Mercedes-Benz

372.820

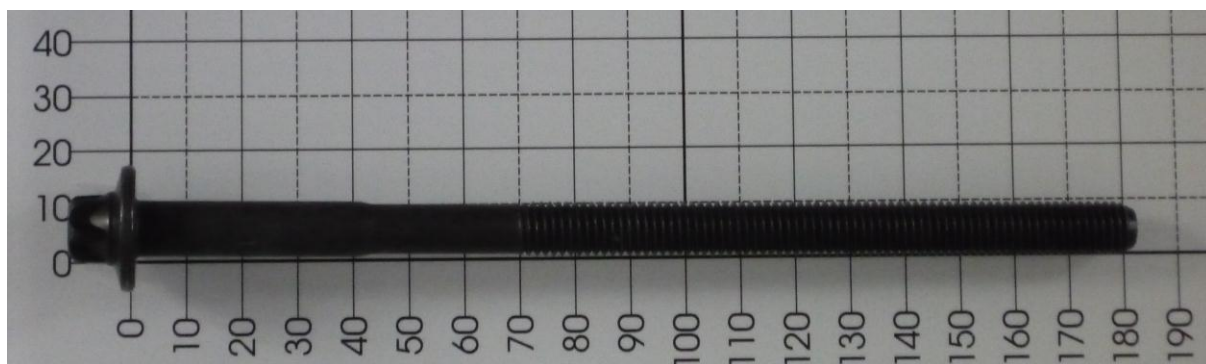
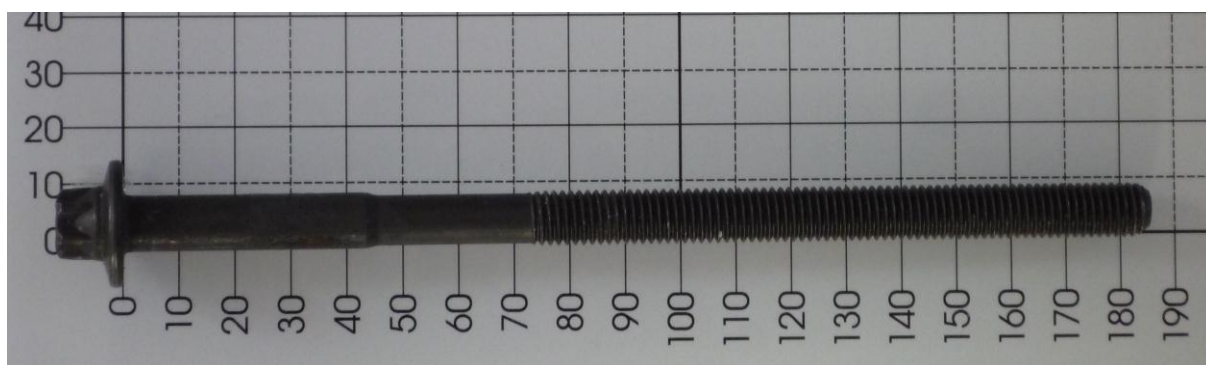
Новый:

372.820

M10 x 1,5 x **179** Torx E14

Старый:

111.360

M10 x 1,5 x **183** Torx E14

- Болты ГБЦ заворачиваются без шайбы.
-  372.820 может заменять  111.360.
